**RESPONSE TO
DOCUMENTS SUBMITTED
TO FTAA FOR MATAMATA
DEVELOPMENT LTD:
ASHBOURNE
DEVELOPMENT**

Notes by Helen Slattery

These notes are in response to documents Submitted on behalf of Matamata Development Ltd for the Fast Track Substantive Application for the Ashbourne Development near Matamata, New Zealand.

Figure 2: Adjacent vacant land potentially affected

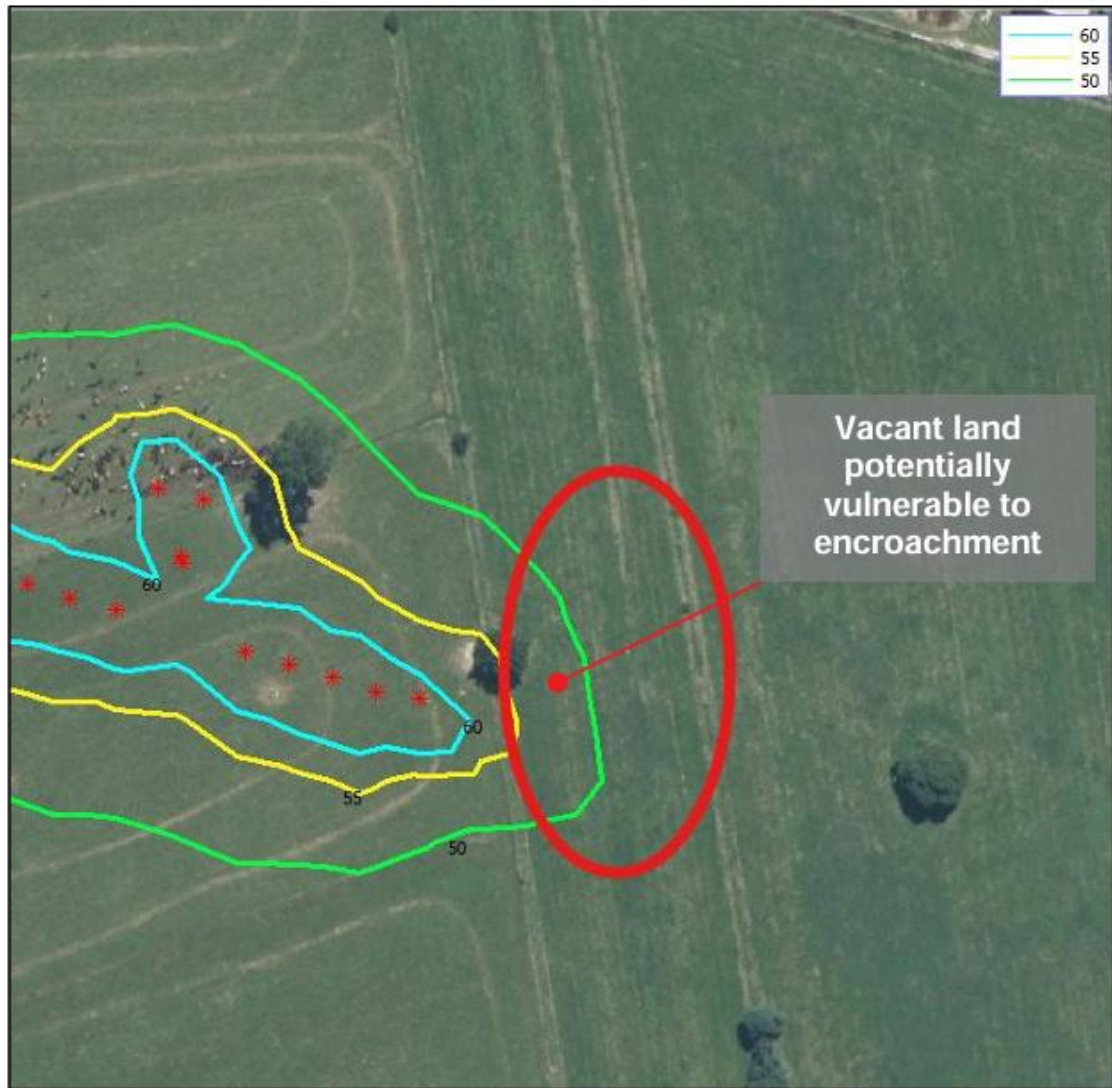
Pg 13 of appendix 3G notes here is a noise issue if a building is constructed on the noise shadow of the inverters 40 m from the eastern boundary of the northern solar farm on the rear lot of 164 Station Road. The noise level 50 dB (A) L10 would be exceeded *the report says Noise level contours shown (Fig 2) show the extent of adjacent vacant land affected by daytime 50 dB (A) L10 noise contours is relatively small, and the potential risk of encroachment is likely to be very low.

Pg 15 of Appendix 1N

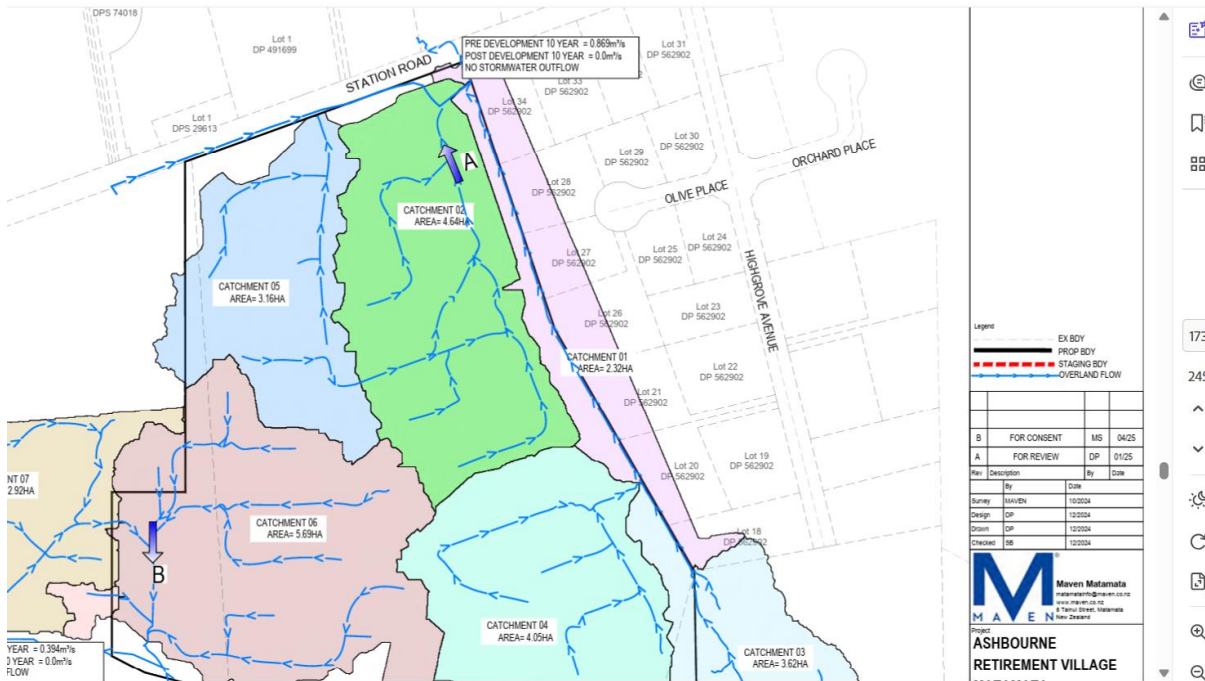
Basin mounding of Stormwater Basin D goes into the neighbouring property, owned by Mrs Odlum.

Pg 174 of 245 100 year flow also reliant on Culvert under Station Road

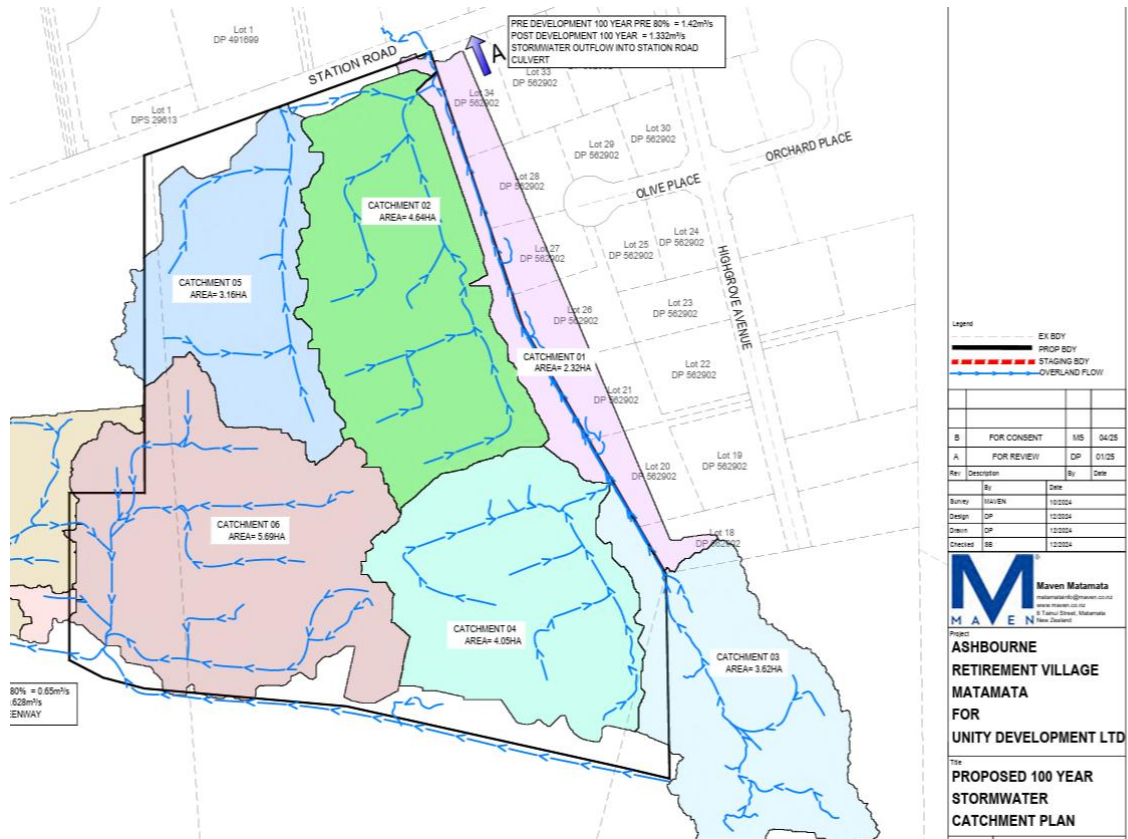
Pg 173 of 245 Stormwater catchment plan of Retirement village (10-year plan), reliant on a small pipe under the road for water to flow away from the site

Acid Sulphate Soils on the Northern Half of the Northern Solar Farm

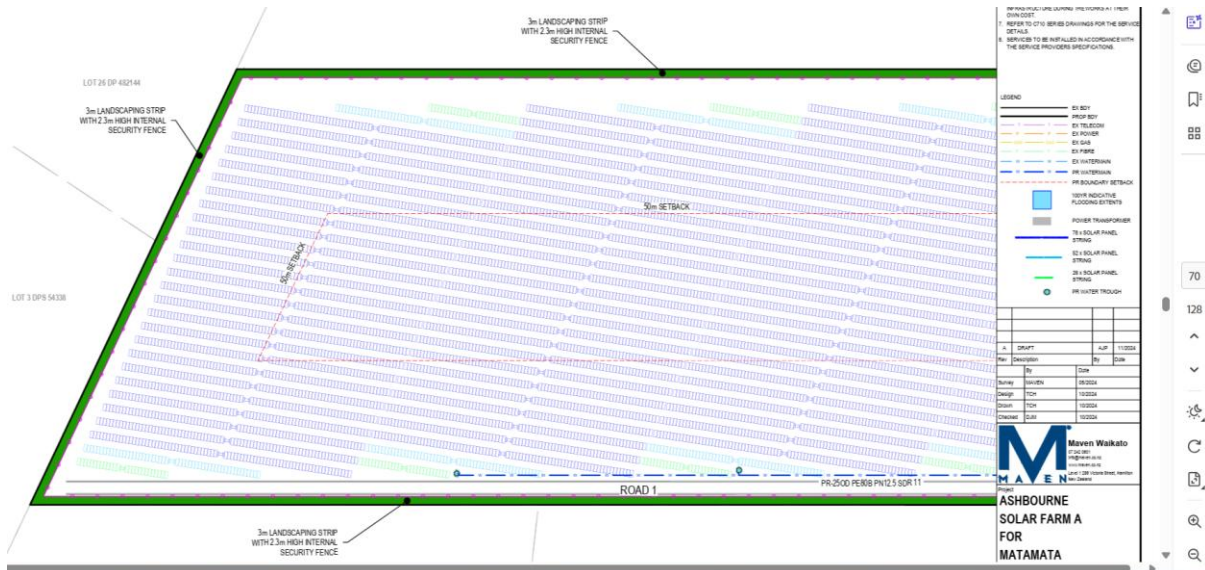
Appendix 1T Acid Sulphate Soil Management suggests that there is a high likelihood of these soils and that the runoff can release acid into the environment. There is a horse training facility that is next to that area of the Northern solar farm, where animals live and people work every day. How can exposure to this be mitigated for those people?
